Fault Slip Analysis

{Note: For Item 8 on Injection Permit work tracker}

Exhibit ???-??? - Fault Block E Gross Sand Isopach

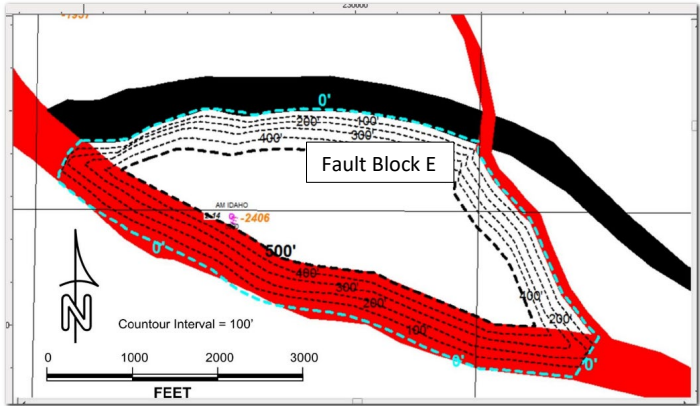
Commented [LZ(2): What is the source of these faults?
Published mapping, or subsurface interpretation?

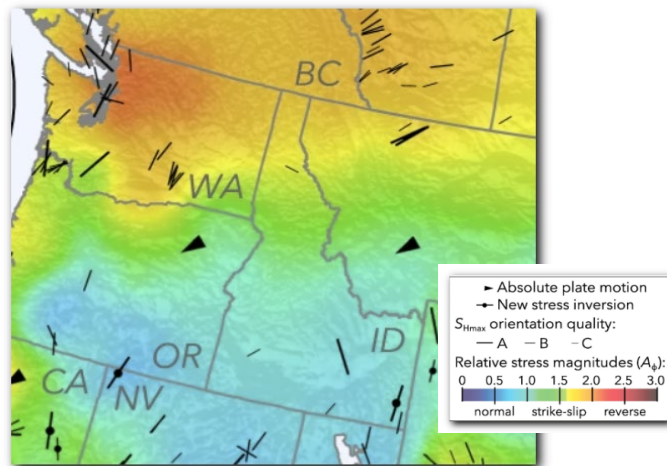
Commented [LZ(3)]: Is there a reference you can cite for this?

Commented [LZ(4)]: Cite publication.

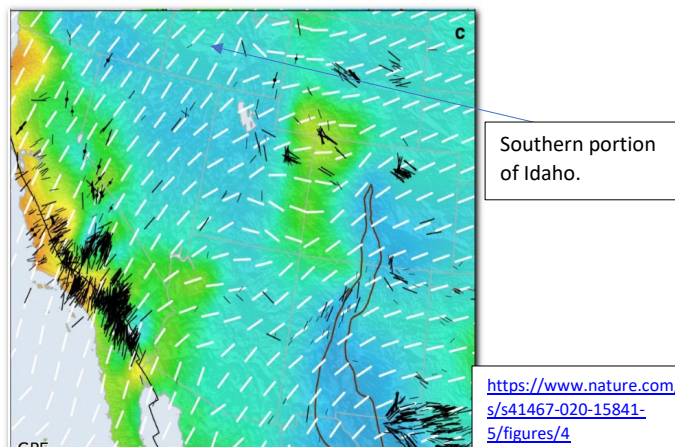
Commented [LZ(5)]: I suggest just citing this in the text and add a "References" section at the end. No need to show a screenshot of the paper.

Exhibit ???-??? Base Case Analysis Results

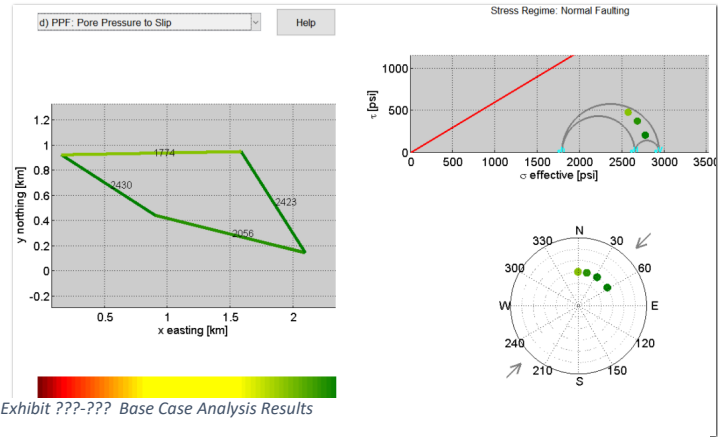
Commented [LZ(9): What is the color ramp scale?

Exhibit ???-??? Summary plot of all faults showing Probability of Fault Slip versus DPore Pressure to Slip

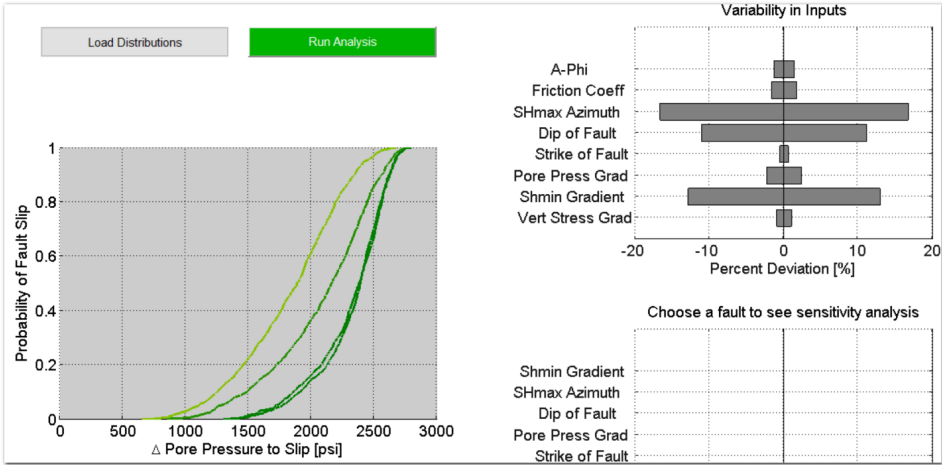
Commented [LZ(10)]: Are each of these lines a different fault? Labels would help here.

Commented [LZ(11)]: What is the conclusion of the analyses? I think a paragraph or two simply summarizing the results and how they apply to the site would be helpful. This would be a good place to remind/emphasize that the models suggest none of the faults would be expected to slip at the pressures of 616 psi. It might be a good place to discuss the probabilities. What probability level is acceptable? 50%? 10%? This can help evaluate the allowable pore pressure changes.

Exhibit ???-??? Fault #3 Probabilistic Fault Slip Analysis

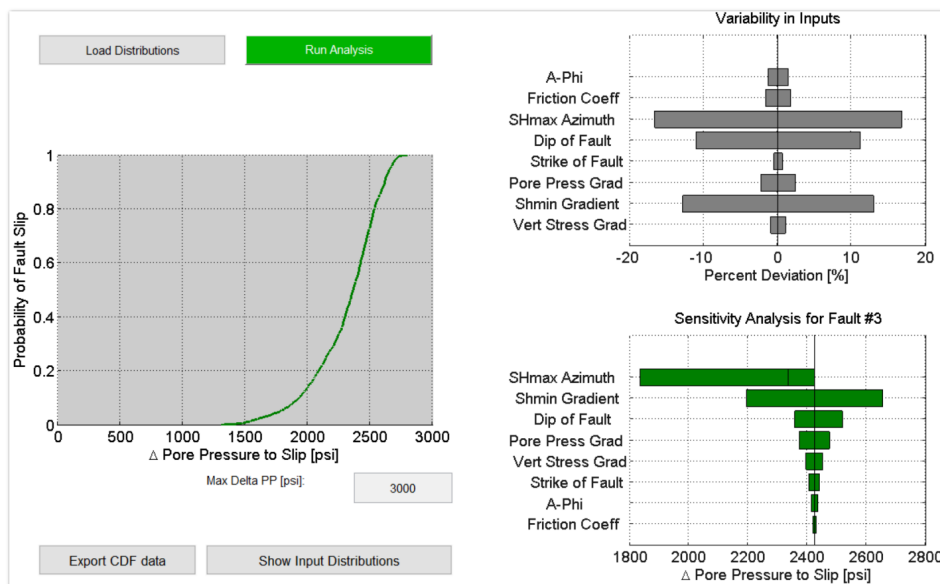
Commented [LZ(12): Sensitivity analysis graph x-axis is cut off.
